<b>Product / Process Change Notification (PCN)</b>	
<input type="checkbox"/> Major Change <input checked="" type="checkbox"/> Minor Change	
<b>PCN Number:</b> PCN_IndCNSA_20250103  <b>Affected Series:</b> WE-CNSA  <b>Affected Order Codes:</b> 784234101, 784234201  <b>PCN Date:</b> 2024-08-02 (YYYY-MM-DD) <b>Effective Date:</b> 2025-01-03 (YYYY-MM-DD)	<b>Change Category:</b> <input type="checkbox"/> Equipment/Location <input checked="" type="checkbox"/> General Data <input type="checkbox"/> Material <input type="checkbox"/> Process <input type="checkbox"/> Product Design <input type="checkbox"/> Shipping/Packaging <input type="checkbox"/> Supplier <input type="checkbox"/> Software
<b>Contact:</b> Product Management <b>Phone:</b> +49 (0) 7942 - 945 5001 <b>Fax:</b> +49 (0) 7942 - 945 5179 <b>E-Mail:</b> pcn.eisos@we-online.com	<b>Datasheet Change:</b> <input checked="" type="checkbox"/> Yes <input type="checkbox"/> No  <b>Attachment:</b> <input type="checkbox"/> Yes <input checked="" type="checkbox"/> No

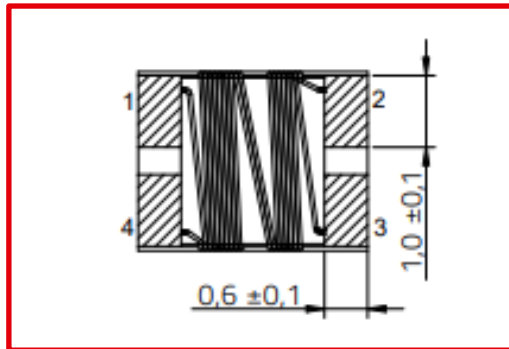
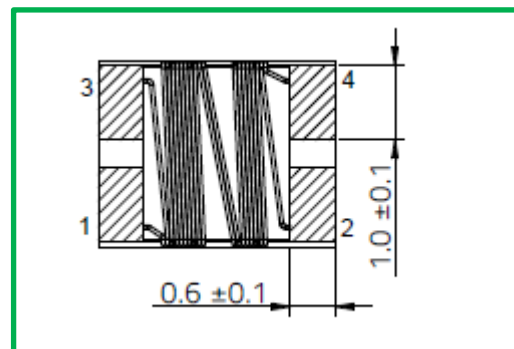
<b>Description of Change:</b> Because of a database mismatch, Würth Elektronik eiSos will update datasheet for order code 784234101 and 784234201. This is a datasheet correction only. There will be no change in form, fit, function, quality or reliability of the product.

Würth Elektronik will update the numbering of the pads in the mechanical dimensions drawing.
